Addendum #2

Bid Opportunity: 24-7536-RFT - Margaret Ave. Public School -HVAC Upgrades,

PROJECT:
22368
MARGARET AVENUE PUBLIC SCHOOL RENOV.

ADDENDUM 02

PARTIAL FLOOR PLANS RENOVATION

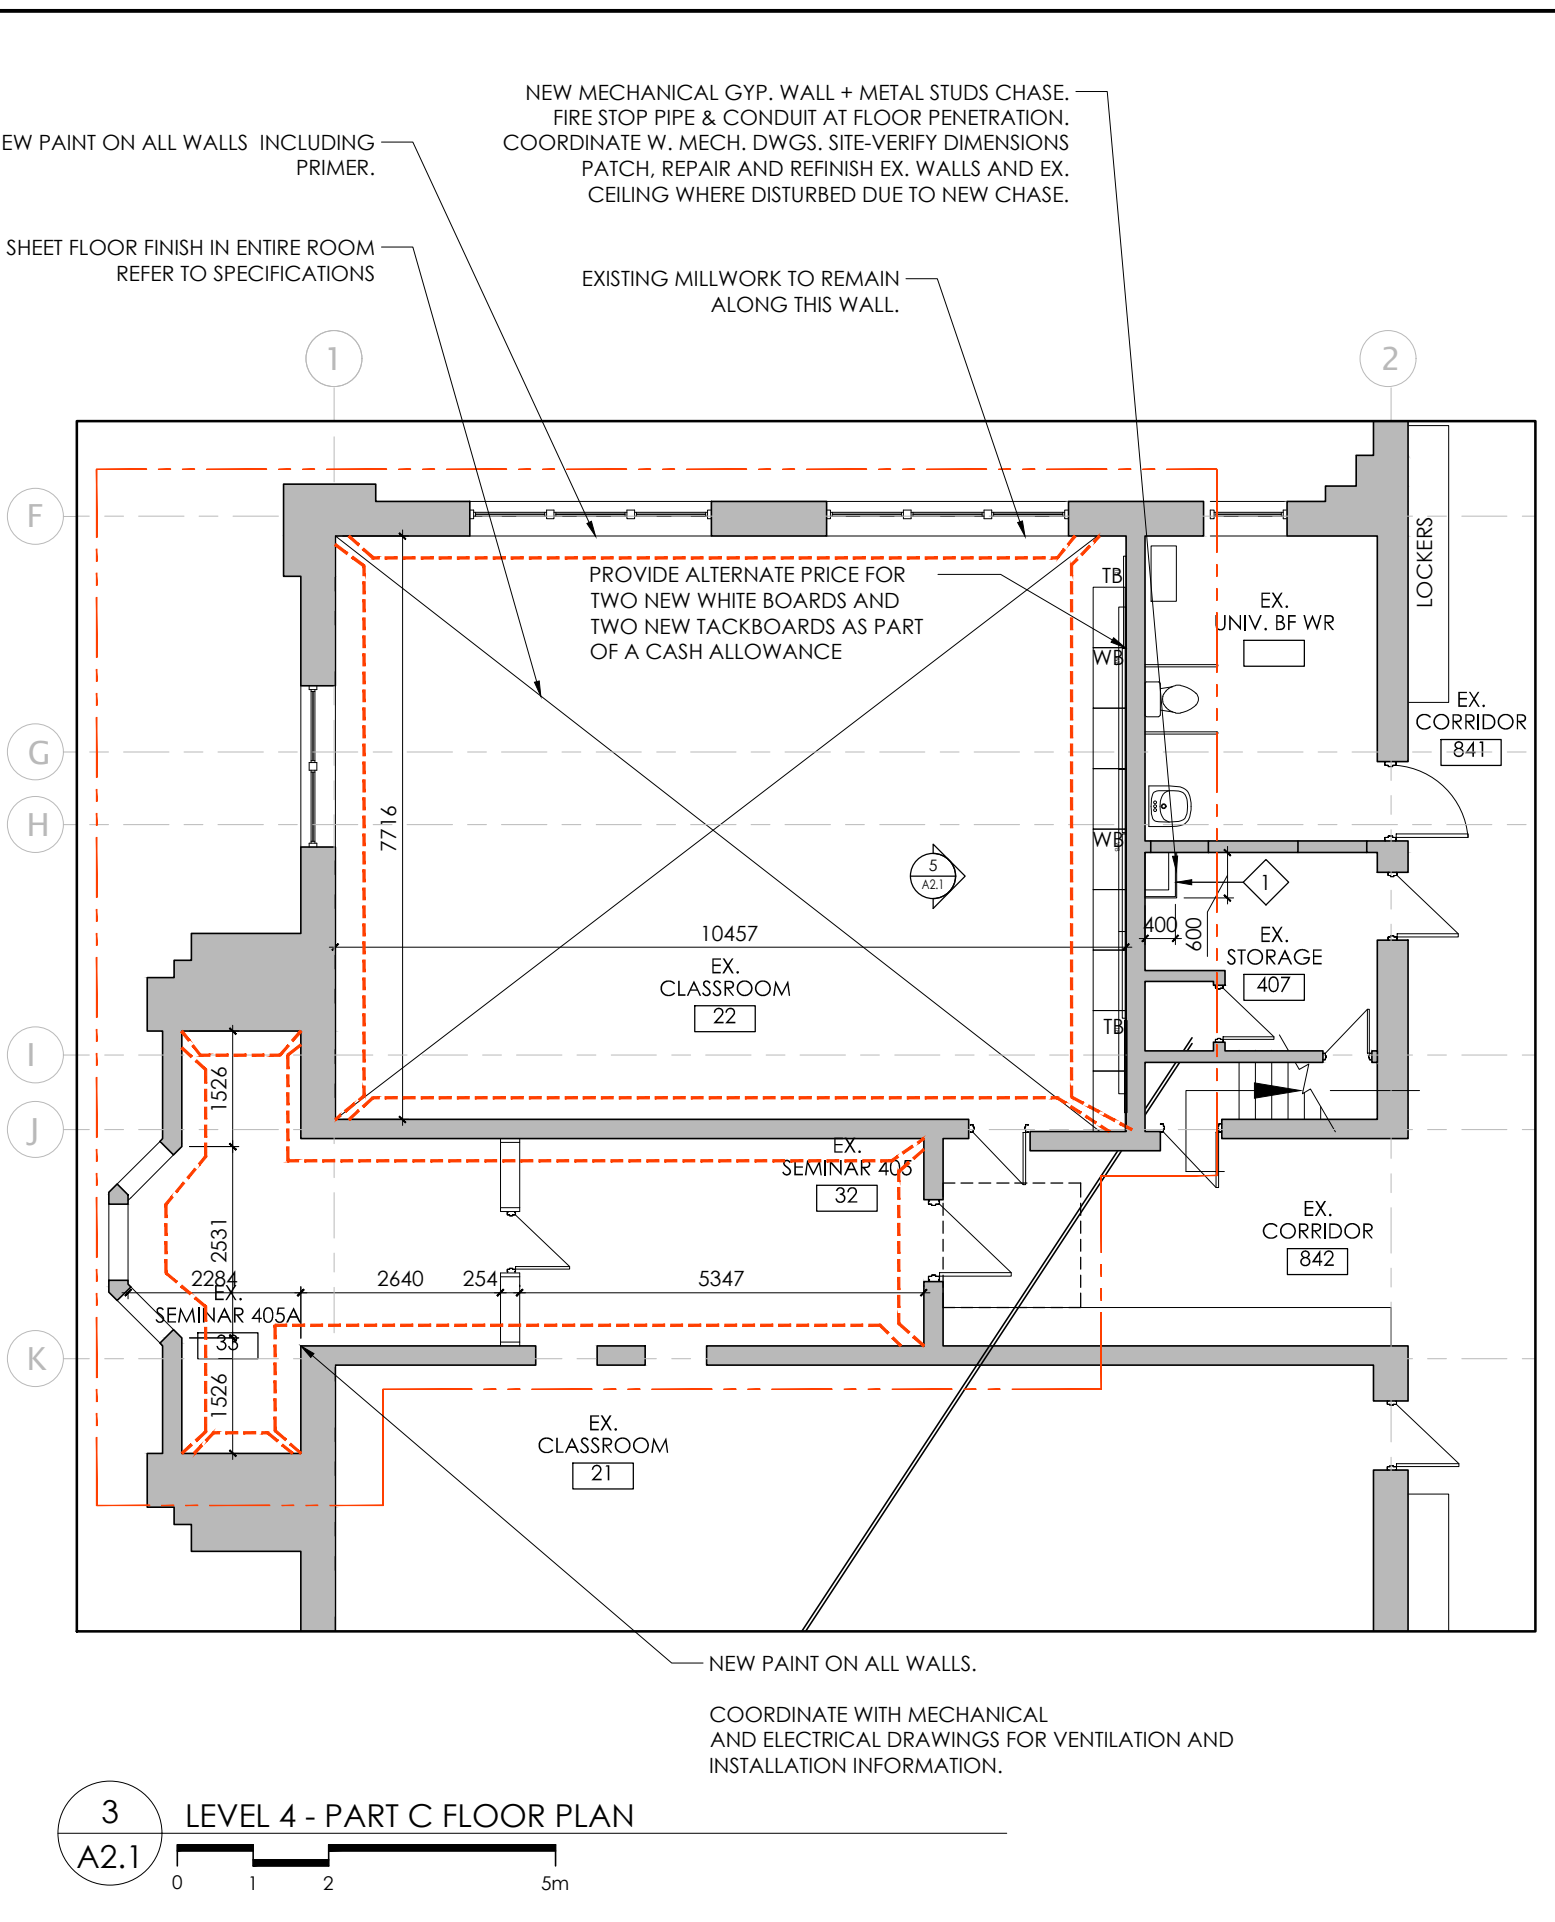
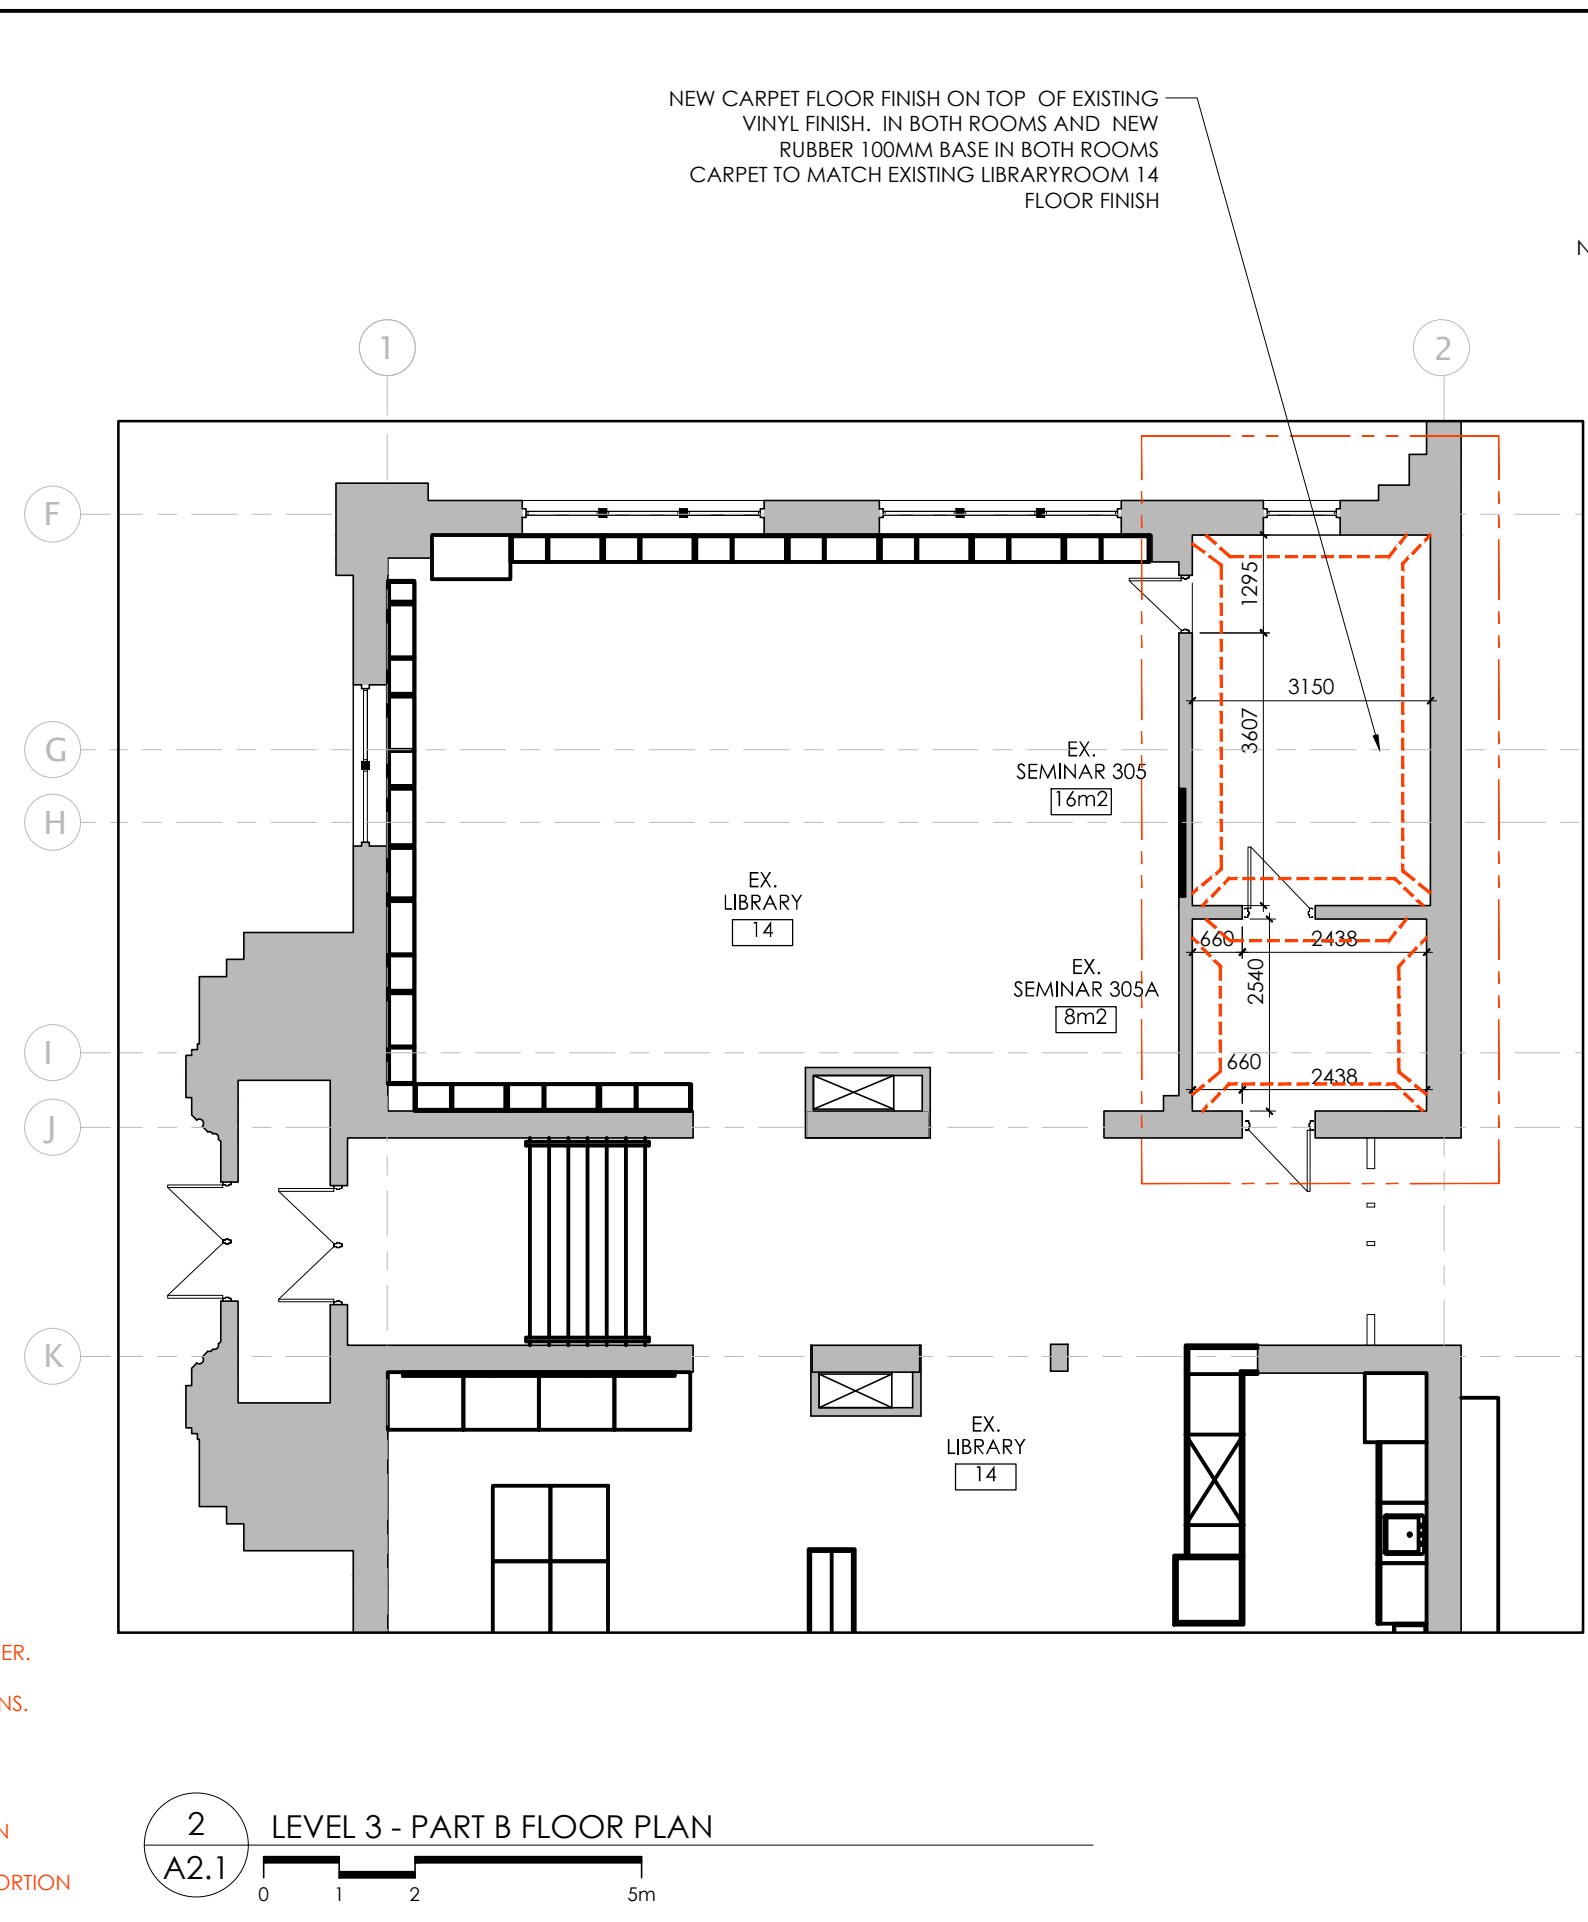
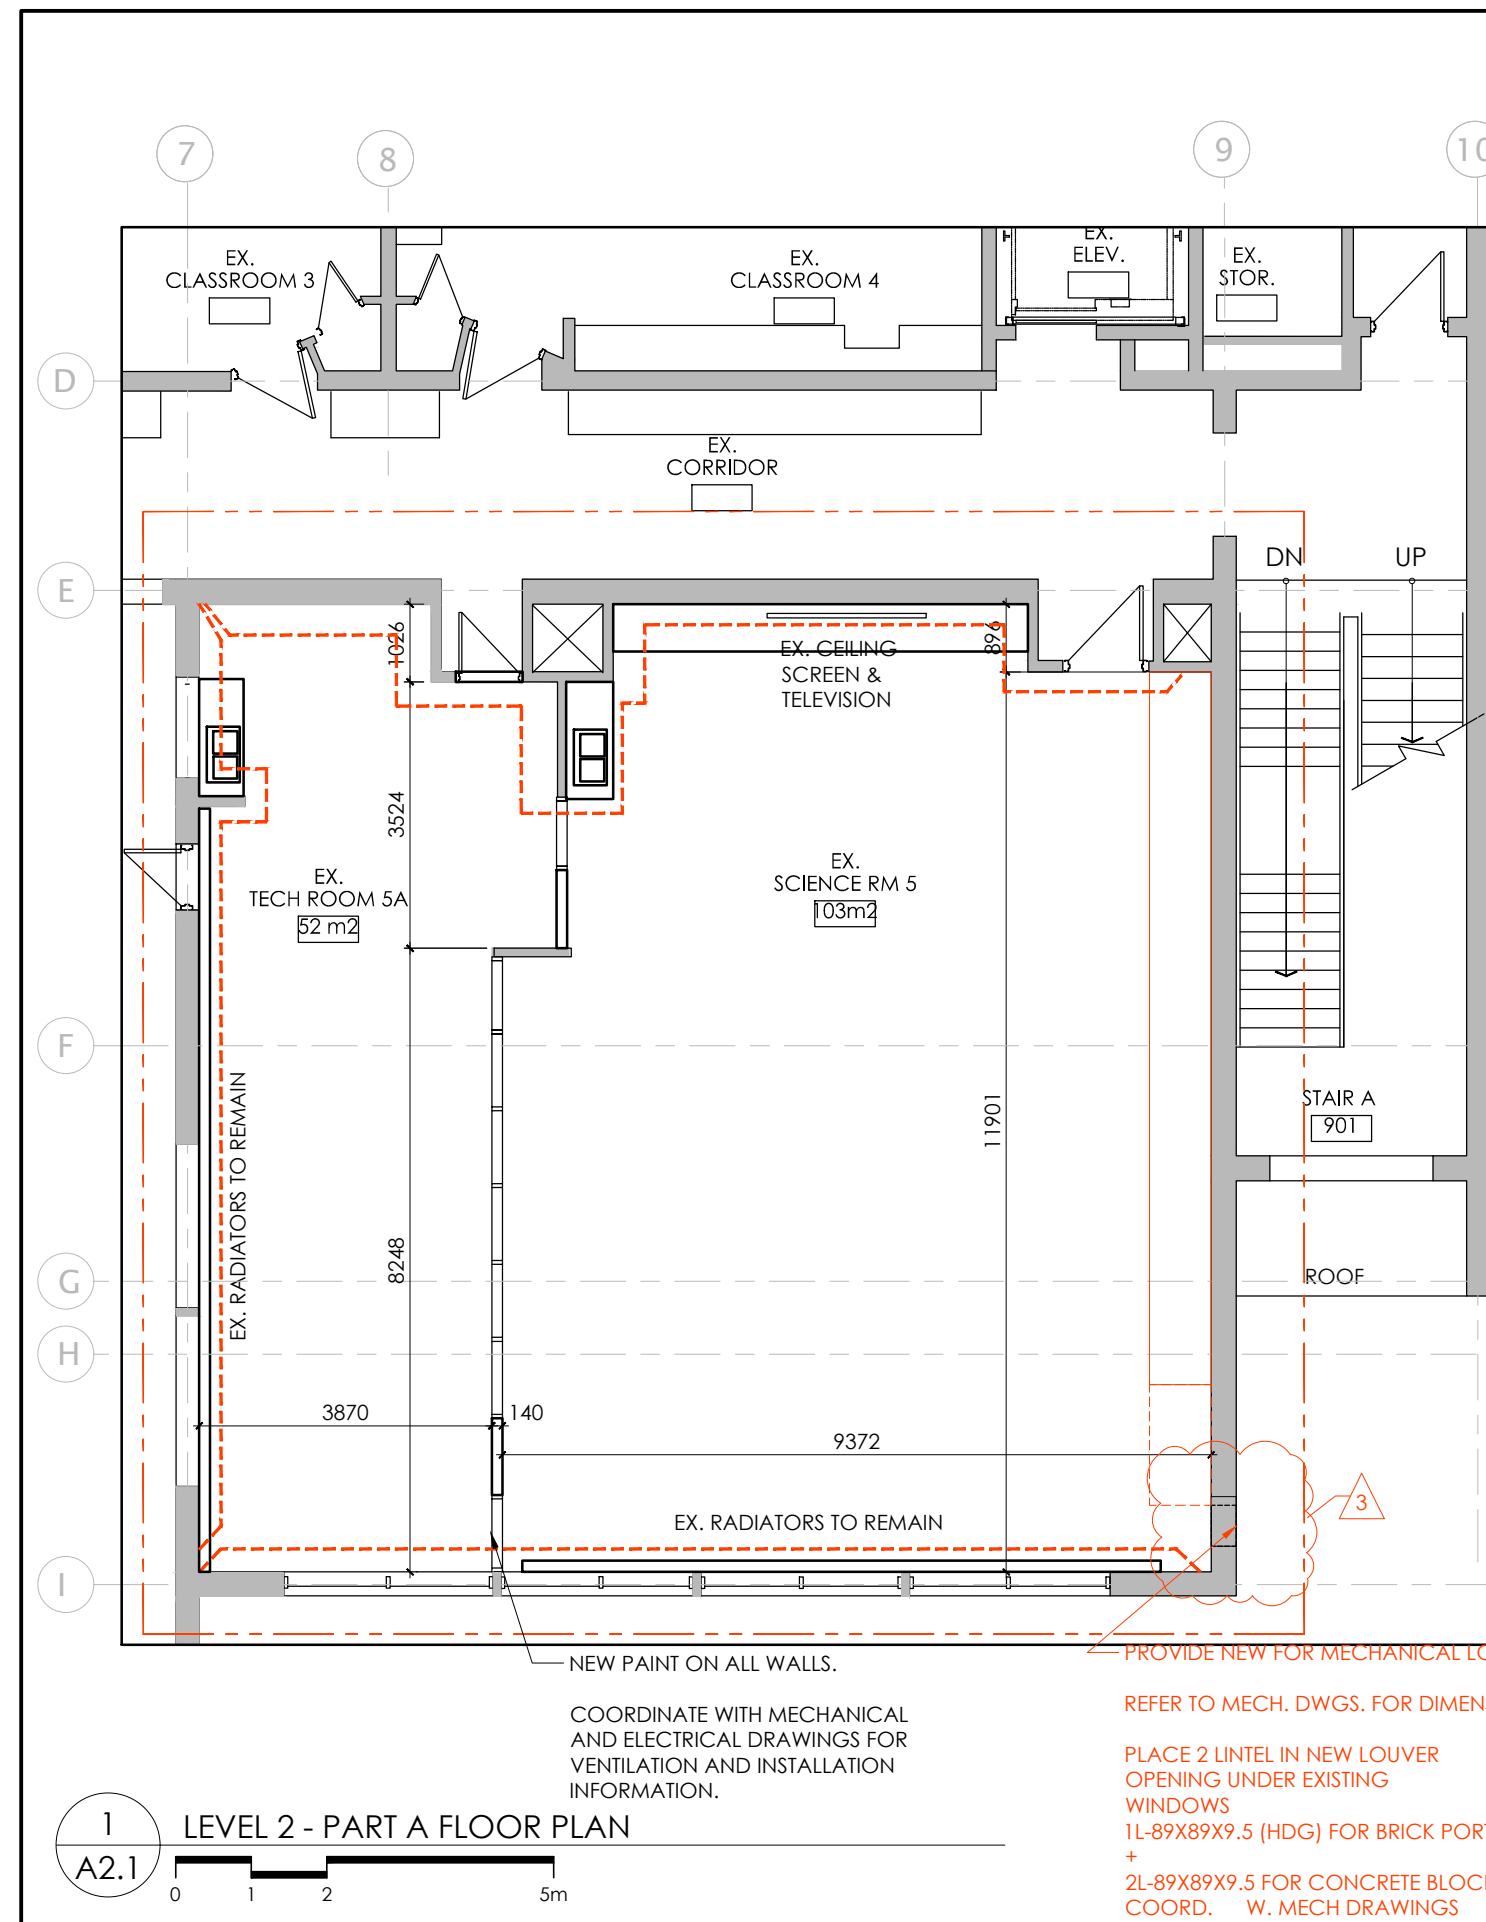
1.
 - i. DELETE drawing **AD2.1 DEMOLITION DRAWING.**
 - ii. REPLACE with attached updated drawing **AD2.1 DEMOLITION DRAWING.**
2.
 - i. DELETE drawing **A2.1 PARTIAL FLOOR PLANS RENOVATIONS**
 - ii. REPLACE with attached updated drawing **A2.1 PARTIAL FLOOR PLANS RENOVATIONS.**
